[Docket No. 98-SW-69-AD; Amendment 39-11528; AD 2000-02-09]

Airworthiness Directives; Agusta S.p.A. (Agusta) Model AB412 Helicopters

ACTION: Final rule; request for comments.

Figure 1

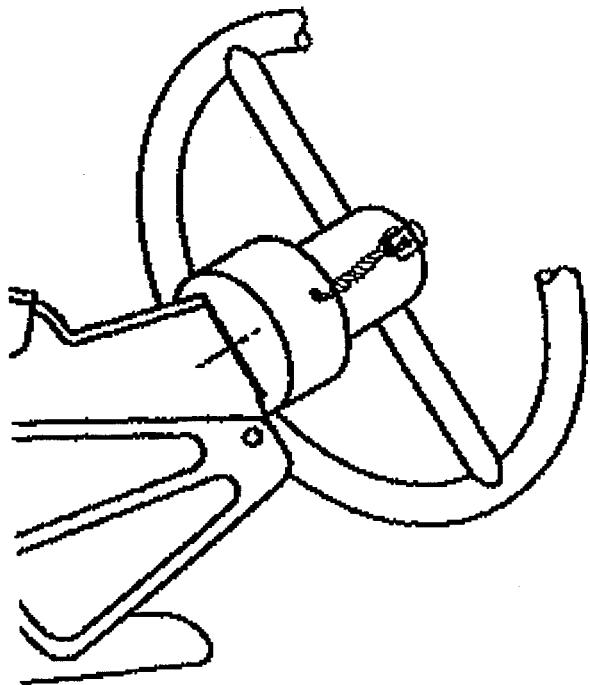
(2) Remove the safety wire and remove and discard the retention pin. Retain the two washers, P/N AN960C816L, for reuse (Figure 1).

(3) Install a zero-hours time-in-service (TIS) retention pin, P/N BL2395, and the two washers, P/N AN960C816L, (Figure 1). Safety wire the retention pin to the hook assembly using safety wire, P/N MS 20995C32.

(3) Inspect the pin, P/N NAS516C4-6 or P/N MS171524, installed on the housing, P/N BL1357-1, and verify the absence of any rotation between the housing and the adapter, P/N BL1355, (Figure 1).

(4) Inspect the rescue hoist hook to ensure it rotates freely relative to the housing (number 3 on Figure 1).

(1) Referring to Figure 1, remove the safety wire and the retention pin. Retain the two washers, P/N AN960C816L, for re-use.

(2) Install the retention pin and the two washers, P/N AN960C816L, (Figure 1). Safety wire the retention pin to the hook assembly using safety wire, P/N MS20995C32.
